Subject: Final Report for Potential 10 CFR 21 Notification SOR Test Report 9058-102 Revision 2

SOR Qualification Test Report 9058-102 Revision 2

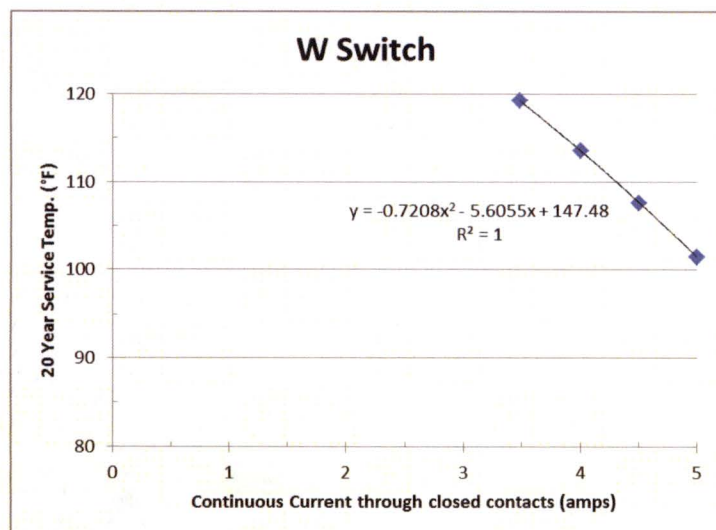
The standard SOR specification for repeatability on Temperature Switches is +/-1% of Span. It is implied that this specification applies throughout the lifetime of the switch. However, qualification testing demonstrated that the repeatability for Temperature Switches is in excess of 1% at numerous times throughout the test program. While the repeatability was previously noted in the test report, it was not identified as an anomaly and therefore there was no disposition. For conservatism, it should be noted that **repeatability could be as high as 1.5%**. This only applies to models beginning with "201", "203", "205", "207", "209", or "20X" (1st location in model number), and ending with "NQ" or "NQX". It also applies to non-standard models 9013932, 9014202, and 9014230.

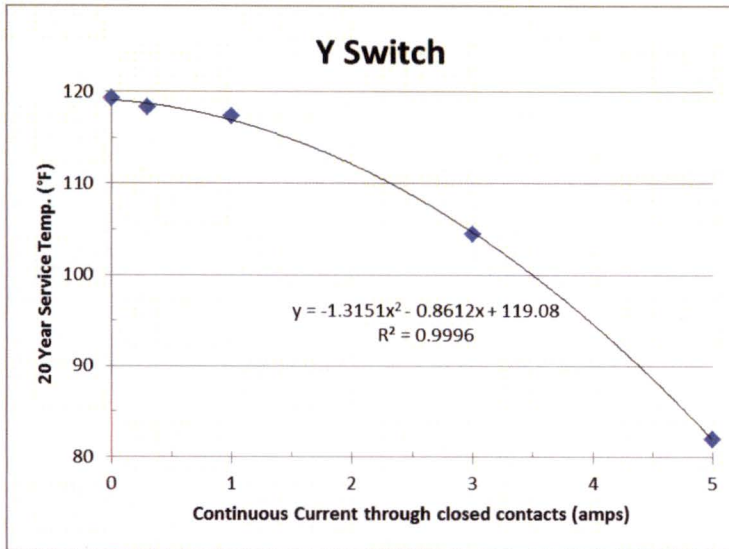
For switches with a "W" switch element (3rd position in the model string) and "NQ" or "NQX" at the end of the model string, the effect on qualified life would be as noted below. Non-standard models 9013545 and 9013761 are also affected. This is based on an activation energy of 1.32 eV.

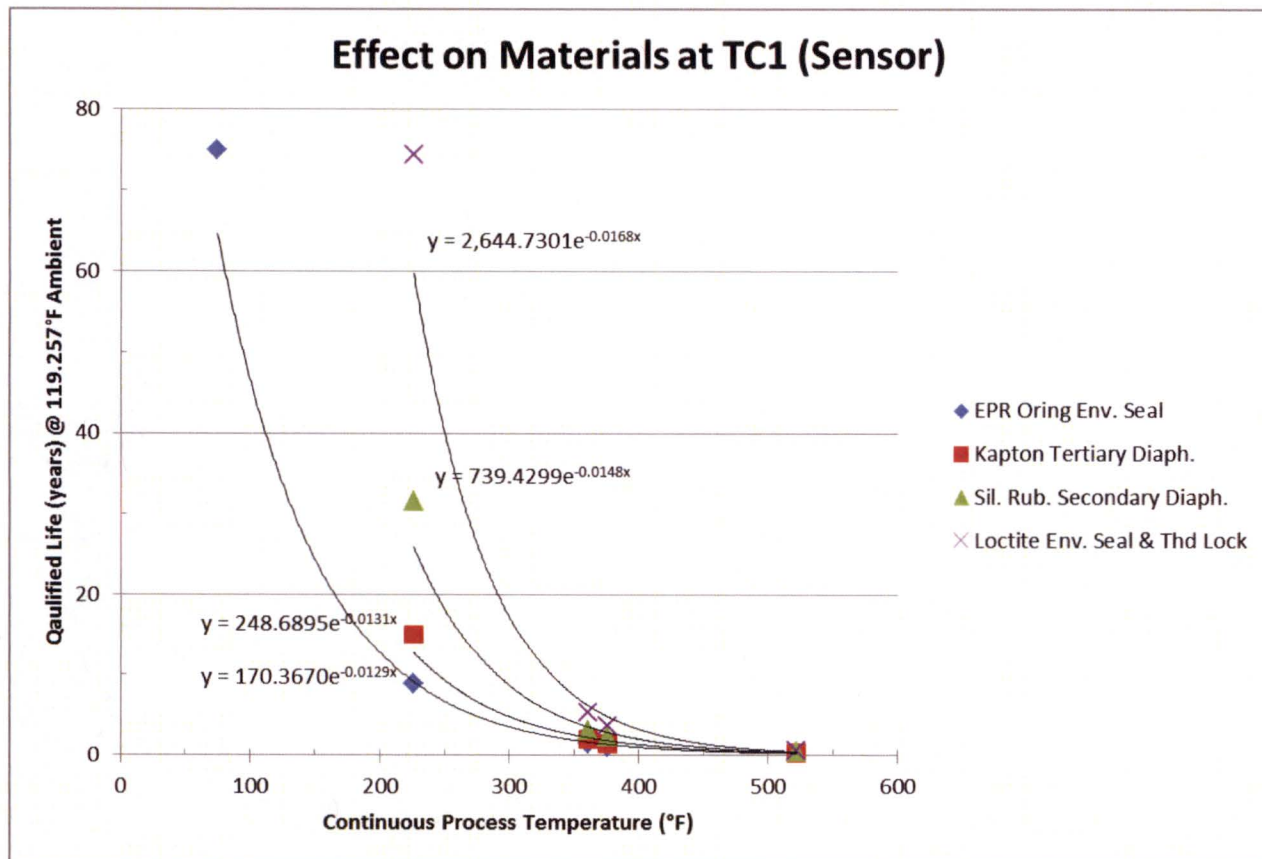
Assuming worst case where an application requires full qualification (seismic and HELB), then the weak links and their effect on life can be summarized as follows;

Assume that the switch contains a "W" or "Y" switch element (3rd position in the model string). Then the qualified life could be calculated by the formula $y = 32.1569 e^{(-0.0055x)}$ where "y" is the qualified life in years (assuming 119.257°F ambient), and "x" is the process temperature in degrees Fahrenheit (assuming continuous exposure to this temperature). This formula represents the weak link up to a process temperature of 225.3°F at which point the weak link becomes the EPR O-ring environmental seal between the sensor and the body. Then the qualified life could be calculated by the formula $y = 170.3670 e^{(-0.0129x)}$. This formula represents the weak link up to a process temperature of 520°F which is the highest rated over-range temperature available in an SOR nuclear qualified temperature switch.

Assume that the switch contains a "B" or "BB" switch element (3rd position in the model string). Due to the high activation energy of the "B" and "BB" switch elements, then the first and only weak link is the EPR O-ring used as an environmental seal between the sensor and the body. The qualified life would be calculated by the formula $y = 170.3670 e^{(-0.0129x)}$ where "y" is the qualified life in years (assuming 119.257°F ambient), and "x" is the process temperature in degrees Fahrenheit (assuming continuous exposure to this temperature). This formula represents the weak link up to a process temperature of 520°F which is the highest rated over-range temperature available in an SOR nuclear qualified temperature switch.

Effect on Materials at TC2 (Loctite @ Body/Hsg. Joint)

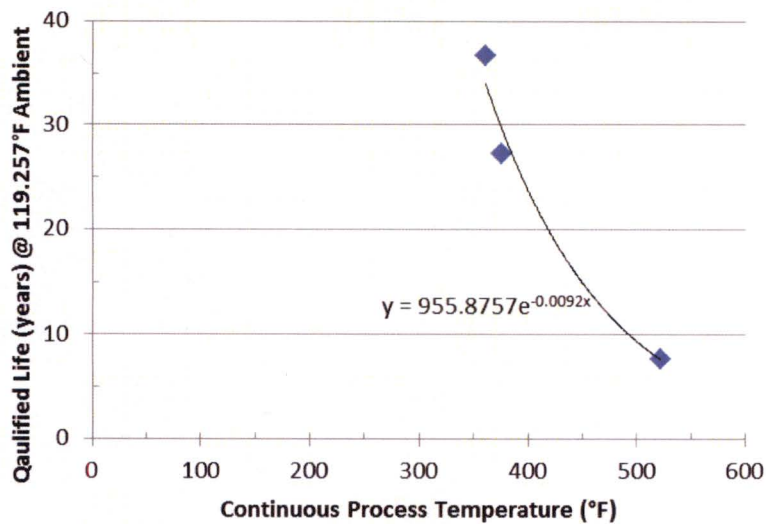
The graphs below are based on temperature measurements at 3 locations on the direct mount temperature switch; TC1, TC2, and TC3. Reference 9058-102, Section 8 for more details.
